TDECQ vs capture bandwidth

Kees Propstra

Proposal for 8023cd_D3p4

TDECQ vs capture bandwidth

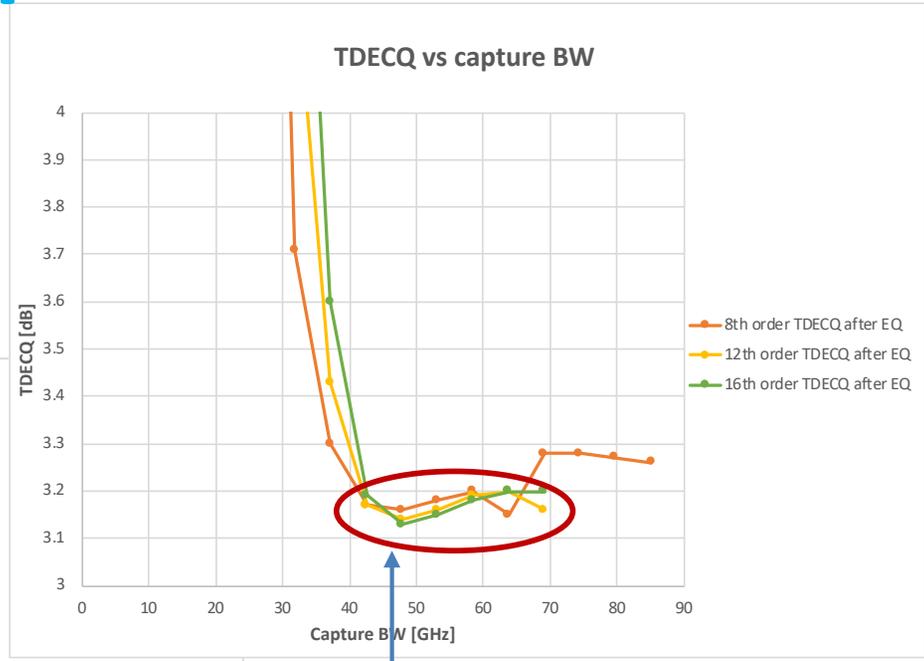
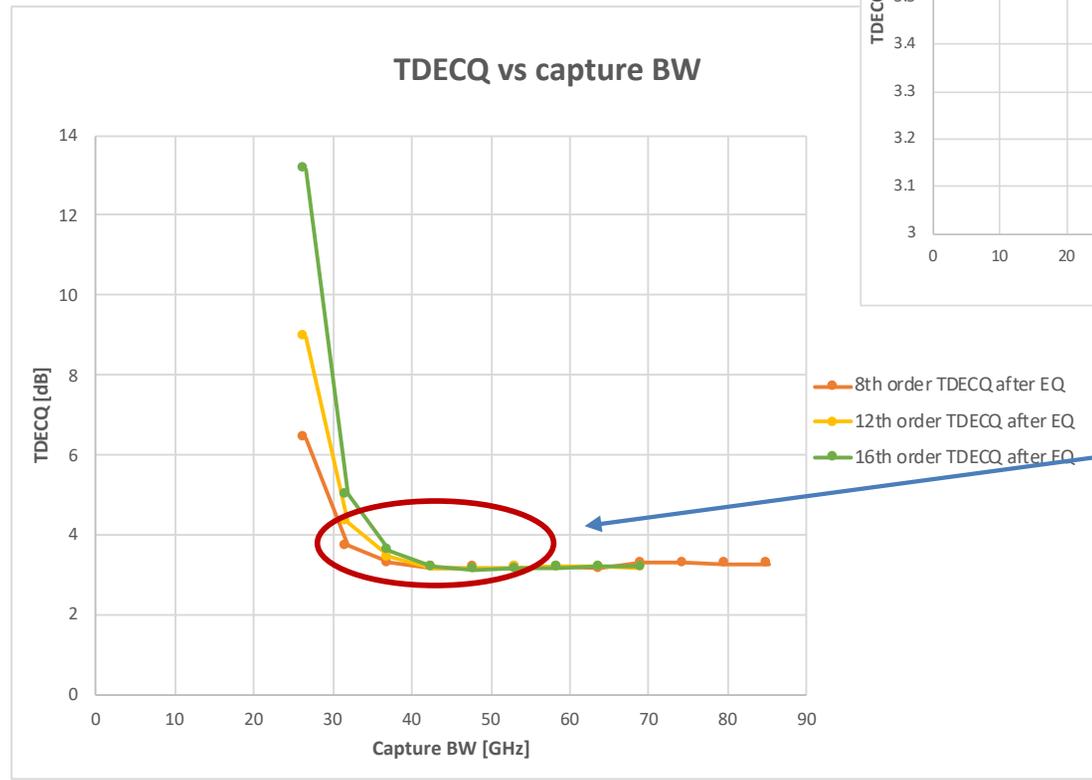
Convergence to final TDECQ value

- error < 0.1 dB @ 42.5 GHz
- order of roll-off has no significant impact

TDECQ vs capture bandwidth

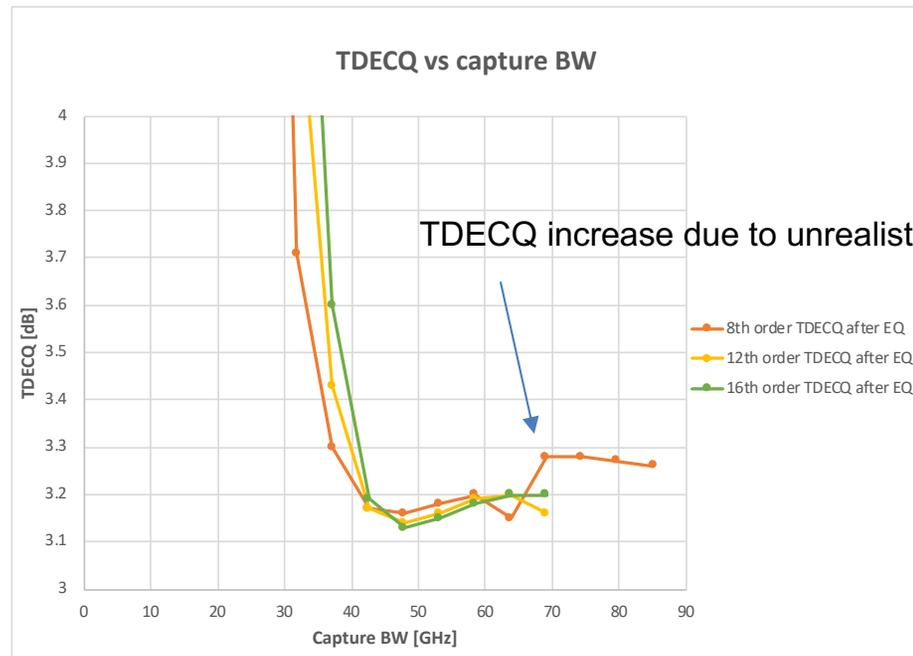
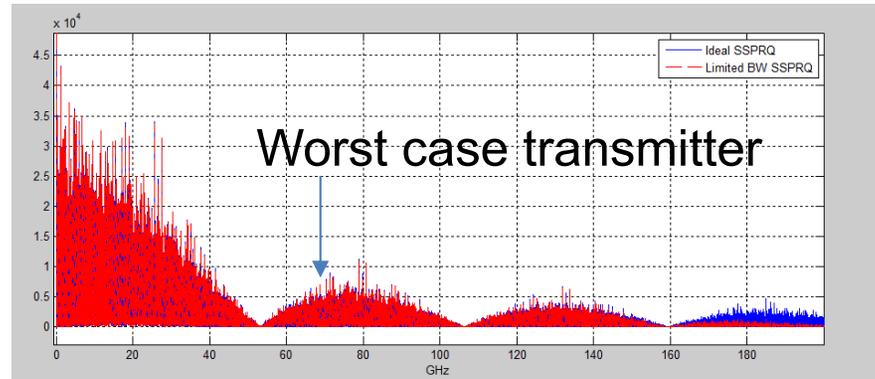
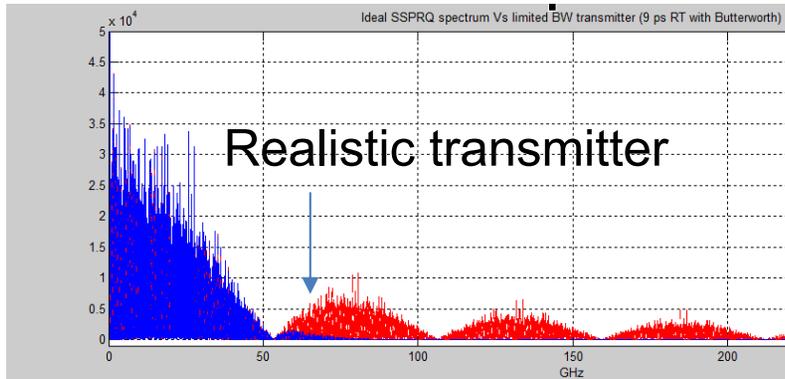
Worst Case Tx

A TDECQ error of less than 0.1 dB can be achieved by a capture bandwidth of 42.5 GHz / 80 % of the Baudrate.*

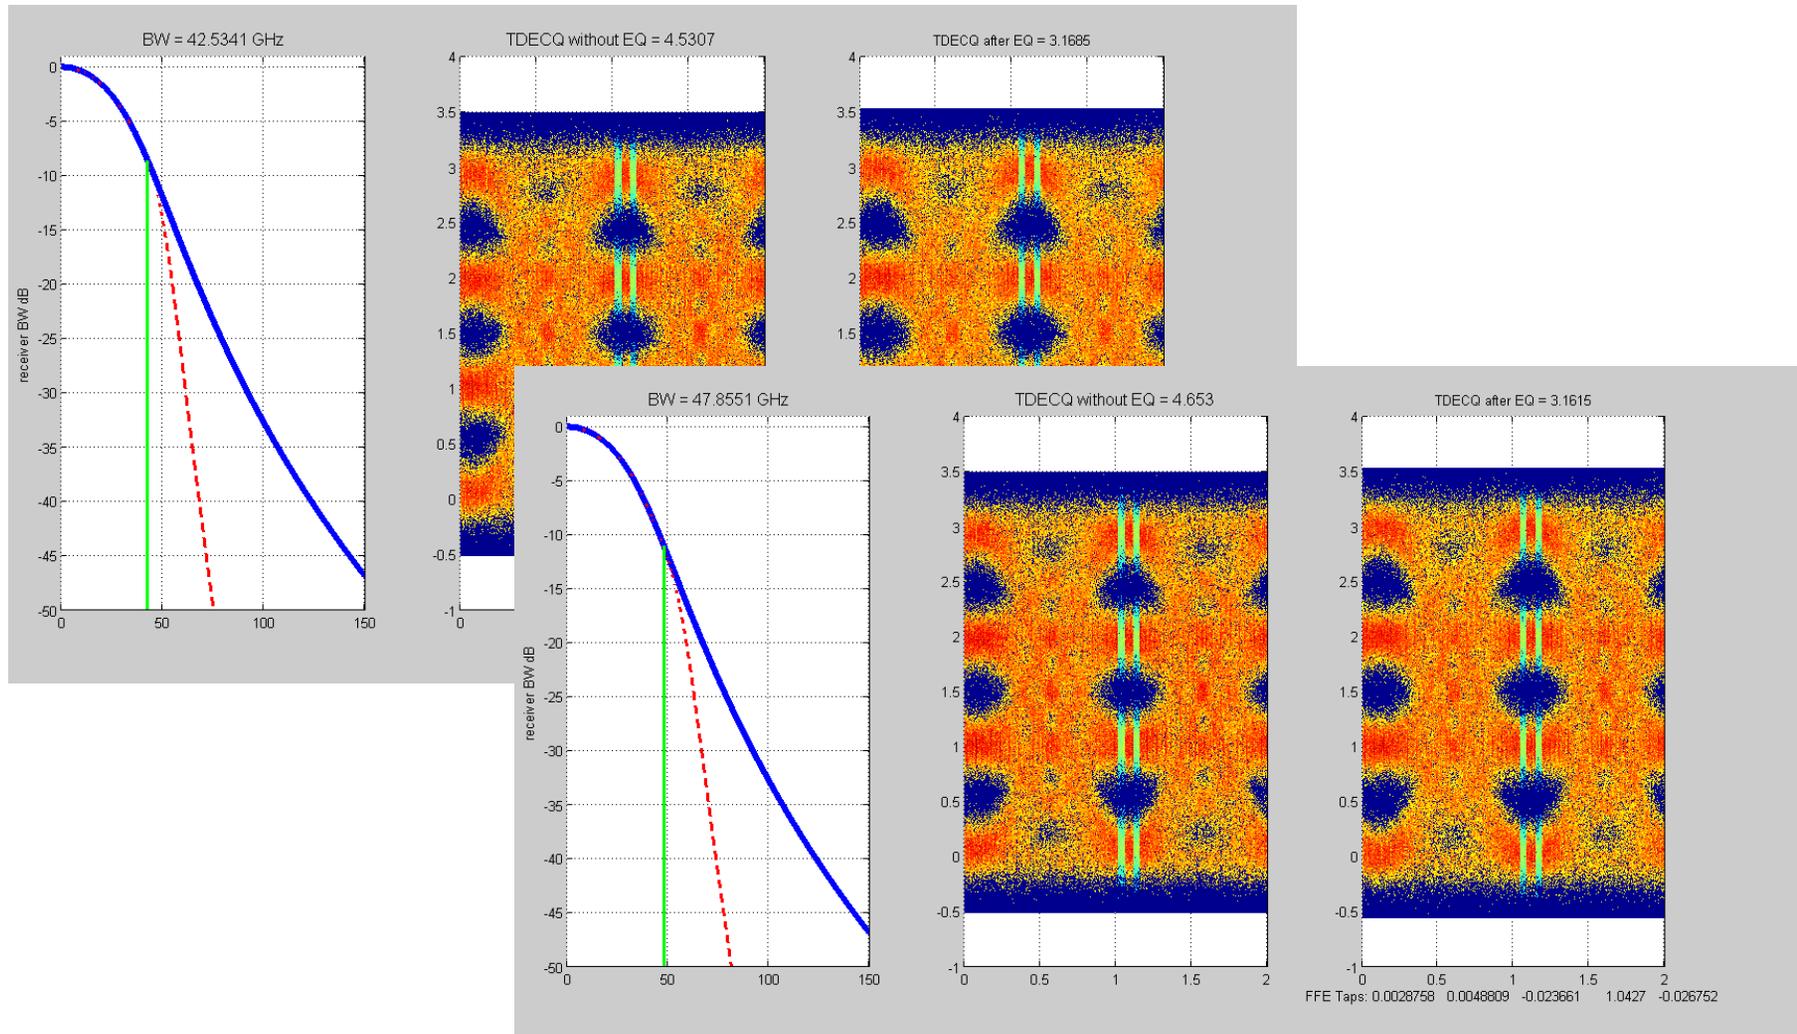
- The combination of the O/E converter and the oscilloscope has a fourth-order Bessel-Thomson filter response with a bandwidth of approximately 26.5625 GHz to at least 1.3×53.125 GHz and at frequencies above 1.3×53.125 GHz the response should not exceed –20 dB.

Replace with proposal on previous page

The combination of the O/E converter and the oscilloscope has a fourth-order Bessel-Thomson filter response with a bandwidth of approximately 26.5625 GHz to at least 0.80×53.125 GHz and at frequencies above 0.80×53.125 GHz the response should not exceed -9 dB.

Compensation may be made for any deviation from an ideal fourth-order Bessel-Thomson response.
